Metropolitan Historic Zoning Commission
Sunnyside in Sevier Park
3000 Granny White Pike
Nashville, Tennessee 37204
Telephone: (615) 862-7970
Fax: (615) 862-7974

STAFF RECOMMENDATION
1503 Clayton Avenue
August 21, 2019

Application: New Construction—Outbuilding (Detached Accessory Dwelling Unit)
District: Belmont-Hillsboro Neighborhood Conservation Zoning Overlay
Council District: 17
Map and Parcel Number: 10409010100
Applicant: William Smallman
Project Lead: Melissa Sajid, melissa.sajid@nashville.gov

1503 CLAYTON AVENUE
GARAGE DADU ADDITION
RIGHT SIDE ELEVATION

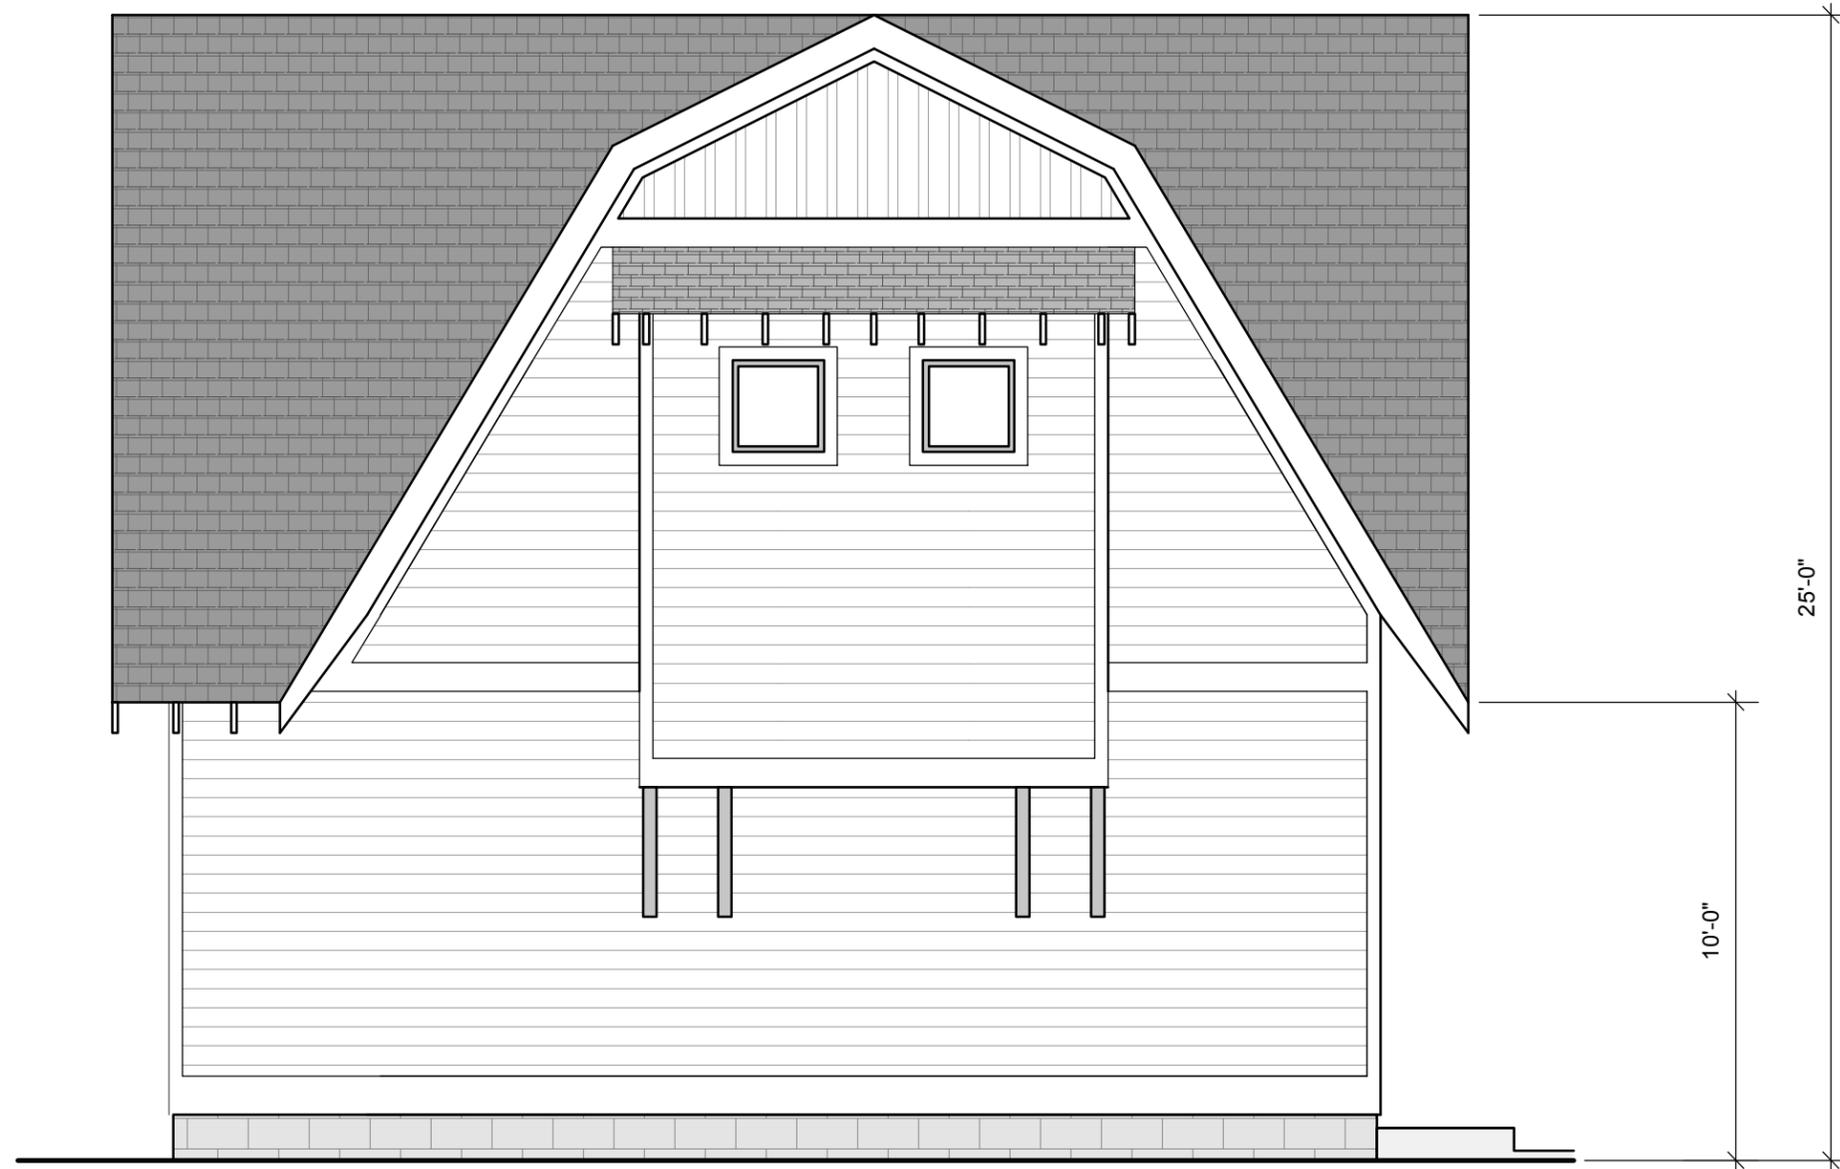
The footprint of the outbuilding is seven hundred and fifty square feet (750 sq. ft.). The design incorporates a cantilevered upper level projection that will extend two feet (2') beyond the side wall. Staff finds this projection to be appropriate as it helps break up the façade and is keeping with a previous decision by the Commission regarding a two-foot deep upper-level projecting bay. Staff finds that the application meets the design

1. The upper-level projection on the right-side façade shall meet the five-foot (5') side setback; and
2. Staff shall review and approve the roof color, windows, pedestrian door, and garage doors prior to purchase and installation.

1503 CLAYTON AVENUE
SITE PLAN

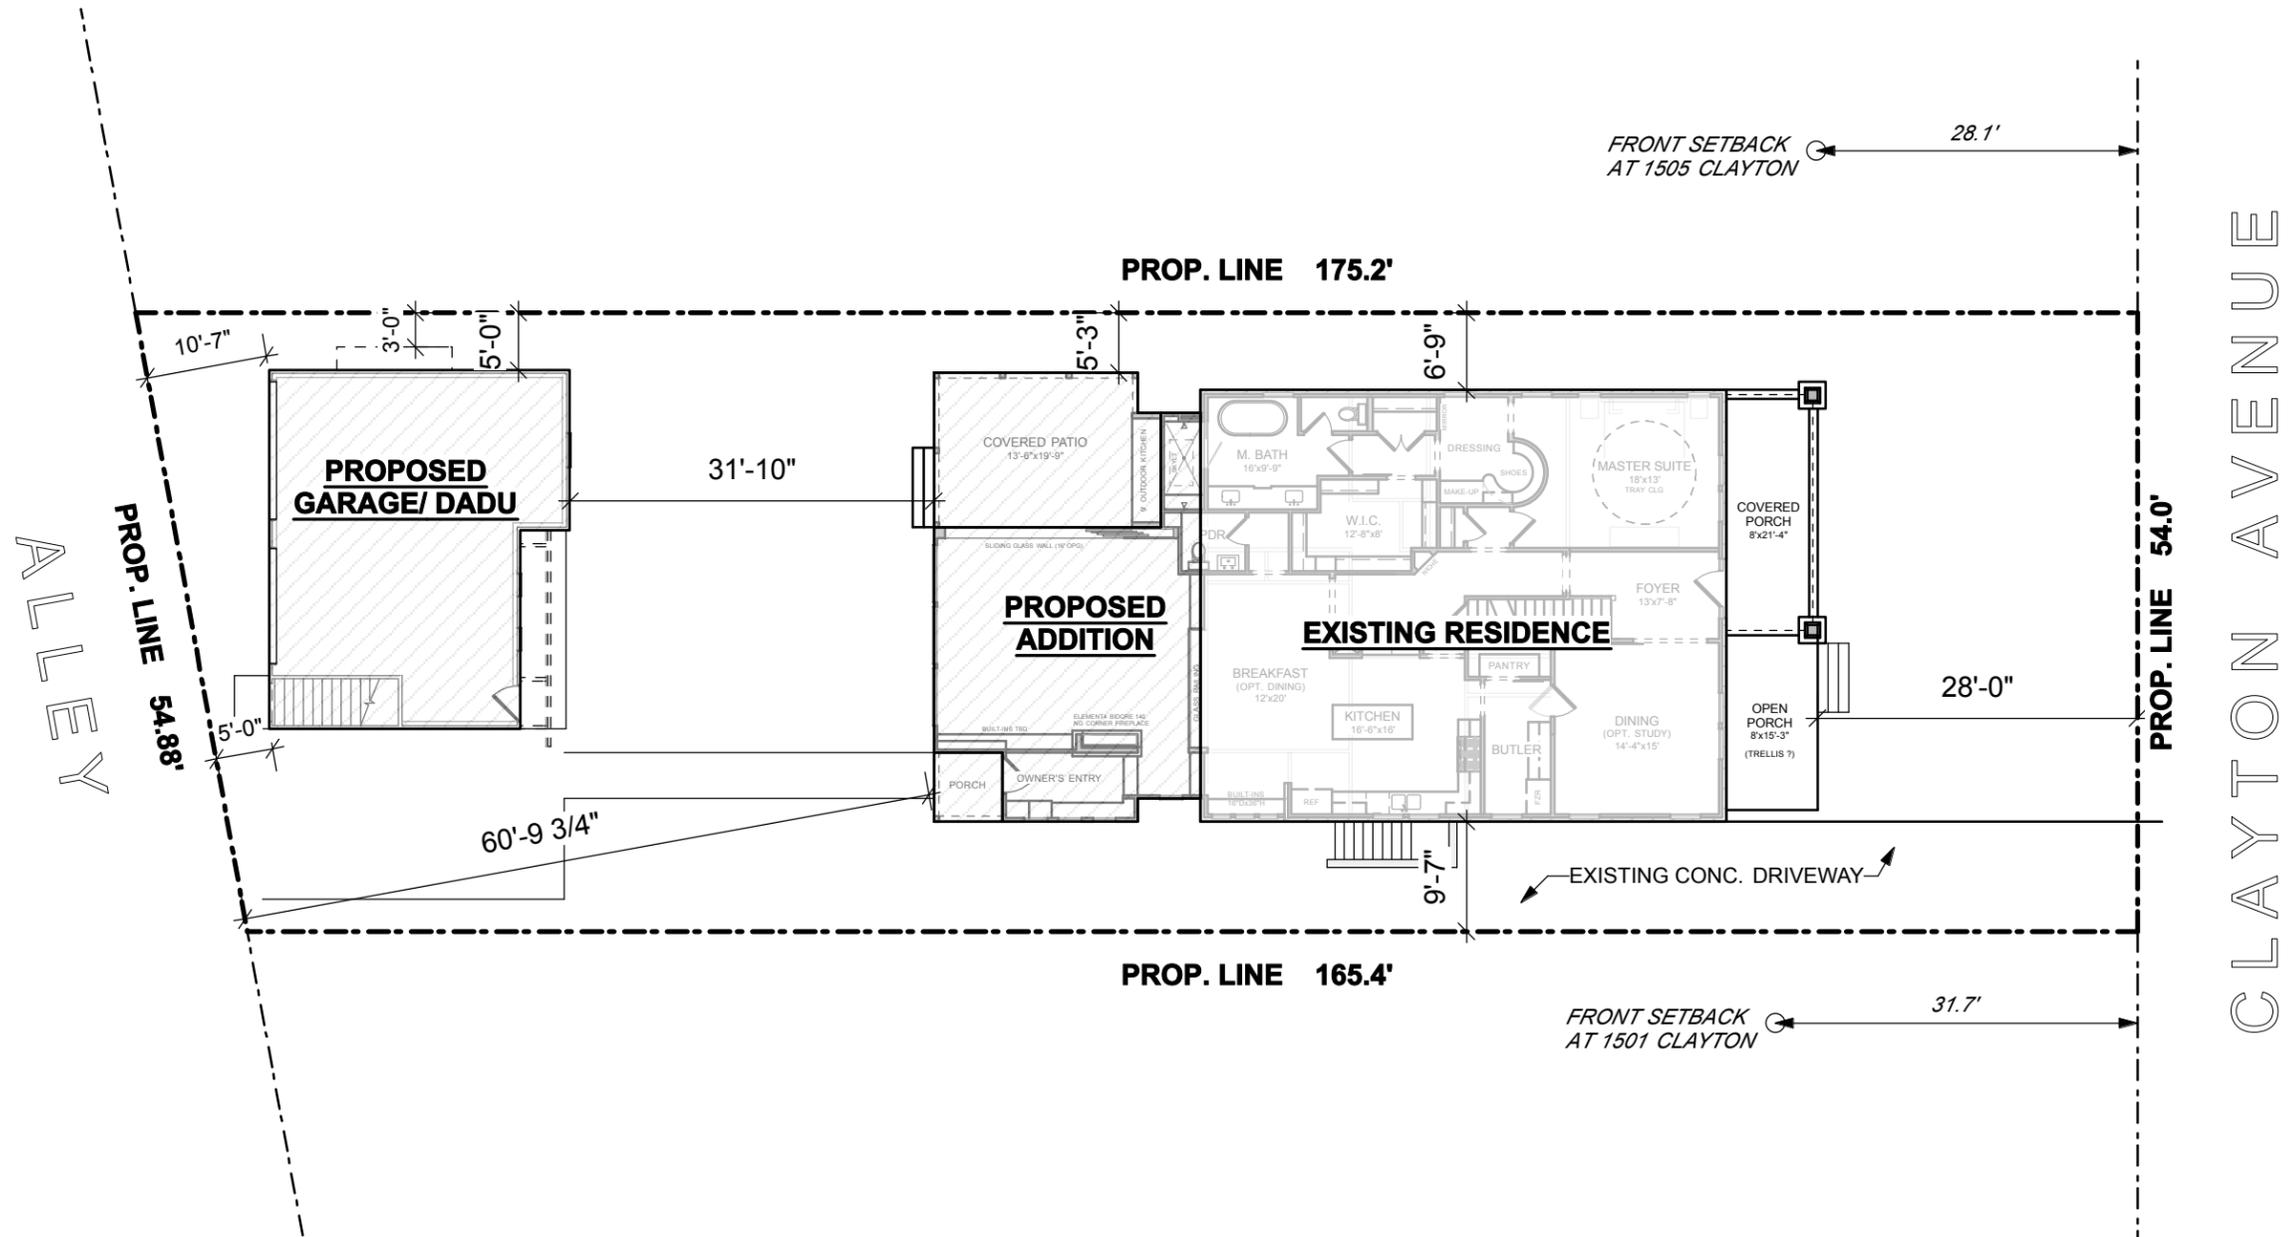
MINIMUM	PROPOSED
Building located towards rear of lot	-	Yes
Space between principal building and garage	20'	31'-10"
Rear setback	5'	5'

Left side setback	5'	18'
Right side setback	5'	3'
How is the building accessed?	-	From alley
Two different doors rather than one large door (if street facing)?	-	N/A

The outbuilding is located at the rear of the lot and will be accessed via the alley. As proposed the outbuilding meets all base zoning setbacks except for the right-side setback. Since the footprint of the outbuilding is greater than seven hundred square feet (700 sq. ft.), the minimum side setback is five feet (5'). While the primary side wall of the outbuilding meets the side setback, the cantilevered upper-level projection does not. The Zoning Code does not permit this type of element to encroach in the side setback. Staff finds that a setback determination to reduce the side setback to three feet (3') would not be appropriate in this case since such projections were not seen historically on outbuildings and since there is room on the lot to accommodate the required five-foot (5') setback. For these reasons, staff recommends that the upper-level projection be set back at least five feet (5') from the property line. The applicant has agreed to this condition.

With the condition that the upper-level projection meet the five-foot (5'), staff finds that the application could meet Section III.B.2.h.2 of the design guidelines and Section 17.16.030.G.4 of the DADU Ordinance for setbacks.
